**MODIFICATION REQUEST TO CONCEPT
APPROVAL AND STATE SIGNIFICANT
DEVELOPMENT ASSESSMENT REPORT:**

**Concept Approval MOD 10
SSD Application for Block 4N**

Central Park (former Carlton United Breweries site)

MP 06_0171 MOD 10 and SSD 6673

Figure 15: The location of the proposed business identification signage zone (Base source: applicant's RtS)

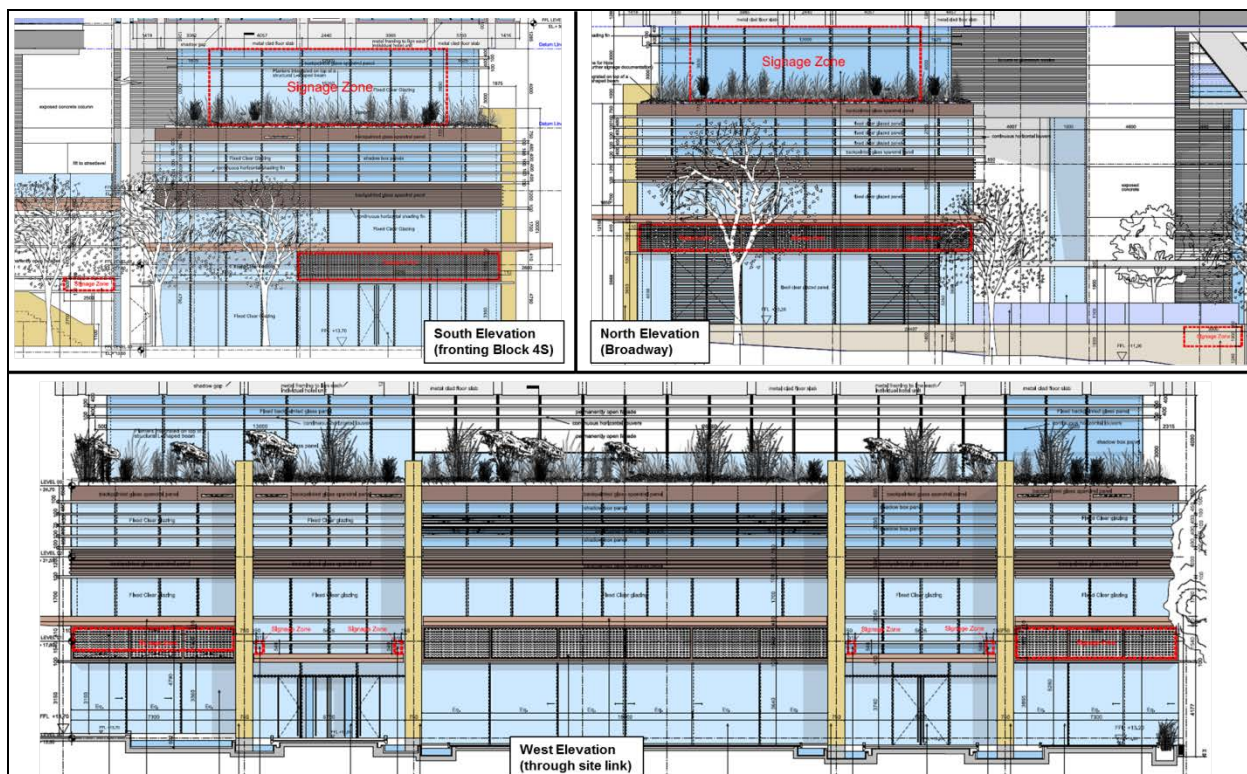
- three signage zones located at ground (17.8m x 1.3m and 3m x 1m) and third floor level (12m x 4m) of the northern elevation fronting Broadway;
- six signs located at ground floor (two 7.1m x 1.3m and four 315mm x 540mm) level fronting the through site link; and
- three signs located at ground (10.3m x 13m and 600mm x 2.5m) and second floor level (12m x 4m) of the southern elevation fronting Block 4S.

The future signage would be illuminated (refer to **Figure 15**).

The Department notes that a SEPP 64 compliance schedule has been submitted with the application, which indicates that a future sign will be consistent with the design and siting criteria of SEPP 64.

The Department is of the view that the scales of the signage zones are acceptable within the overall context of the building and notes that the proposed signage zones are all located at the lower levels of the building, situated above doorways, glazed window-fronts and/or appropriately located within the façade of the building.

The Department has considered the principle of the proposed signage zones and considers that future signs will be capable of being appropriately positioned, proportioned and integrated into the design of the building and are therefore acceptable.

Figure 16: Example of hotel signage lettering within the proposed signage zone on the Broadway (northern) elevation (Source: applicant's EIS)

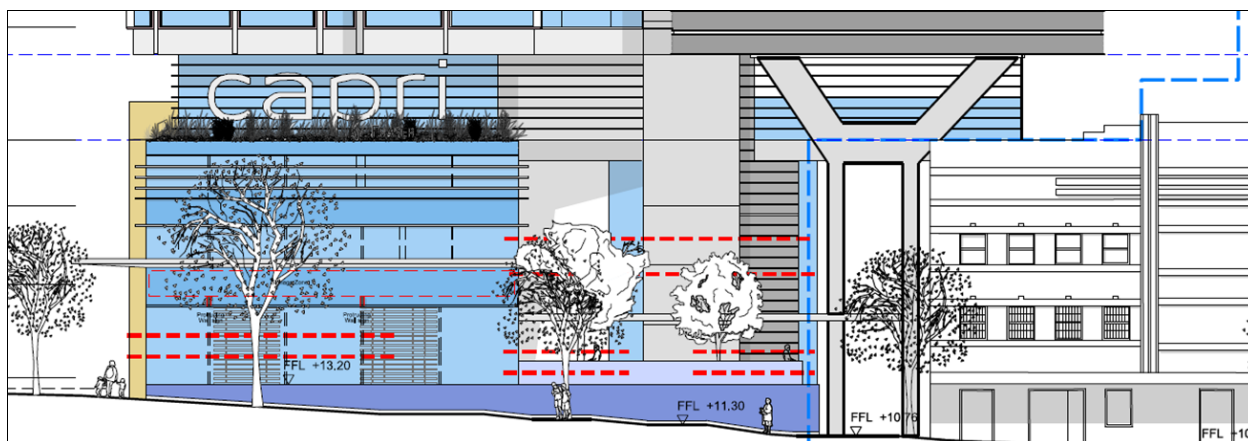
The Department notes the large dimensions of the two hotel signage zones at third floor level (measuring 12m x 4m). However, the applicant has indicated that these zones are expected to contain the halo-lit lettering of the hotel name (refer to **Figure 16**) and would not fill the entire expanse of the signage zone.
